SCI-823-0.00

PID No. 77366

US 52 RAMP A OVER OHIO RIVER RD (CR 503)

PRELIMINARY DESIGN REPORT SUBMITTAL

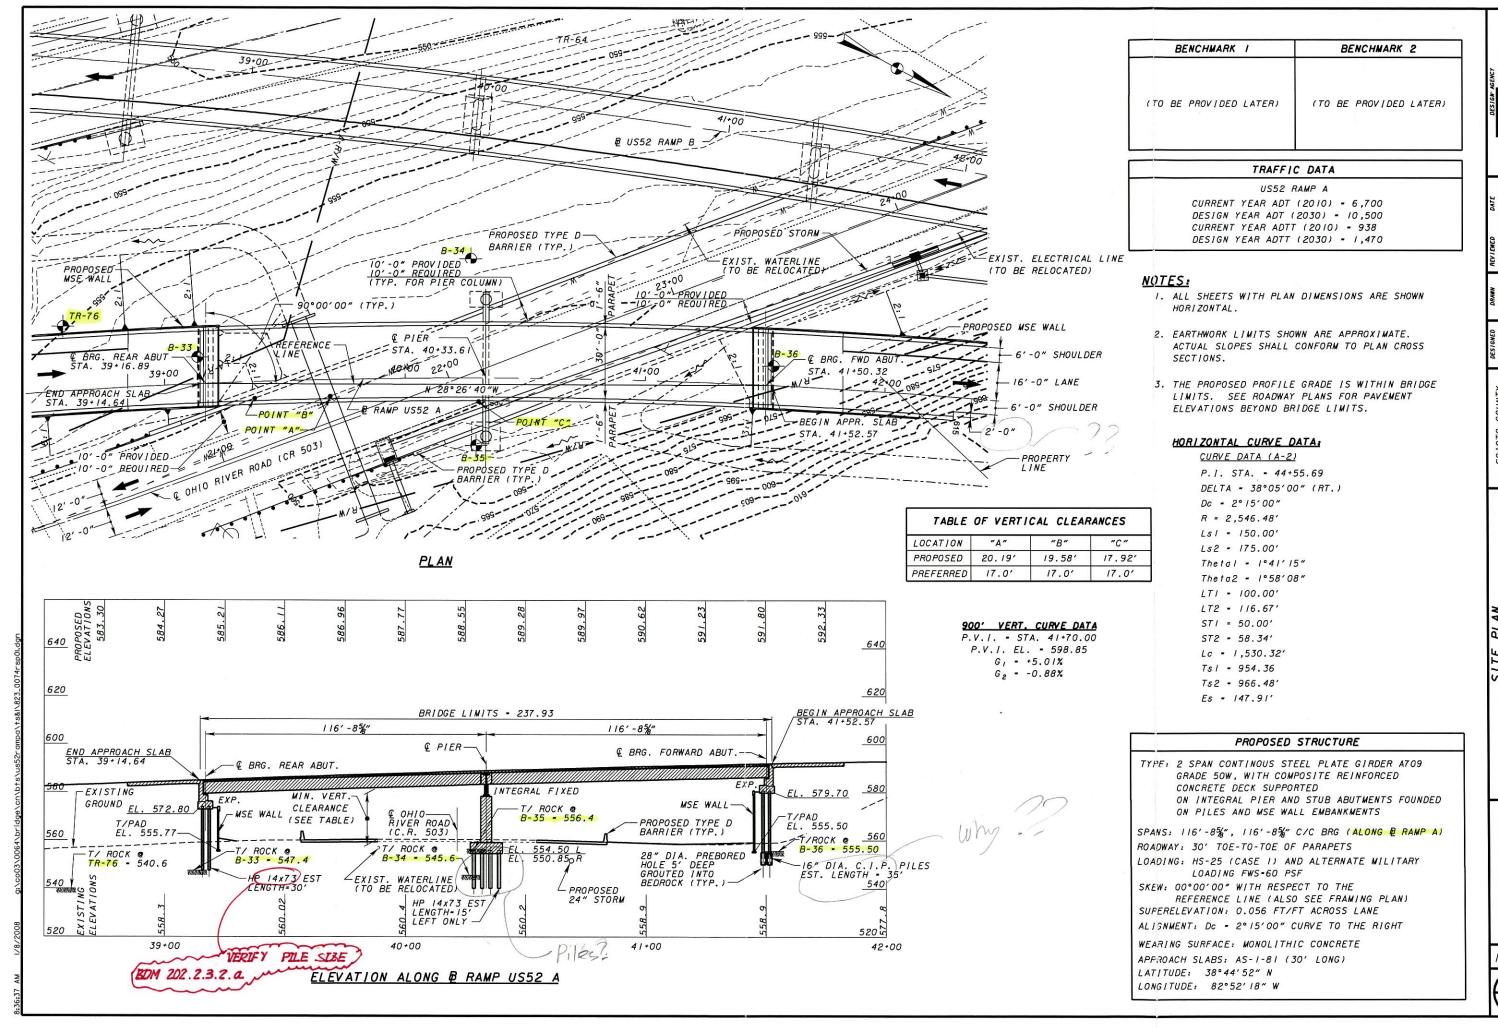
CHECK ROTATION OF FASCIA

WHY NOT 9'-4" ?
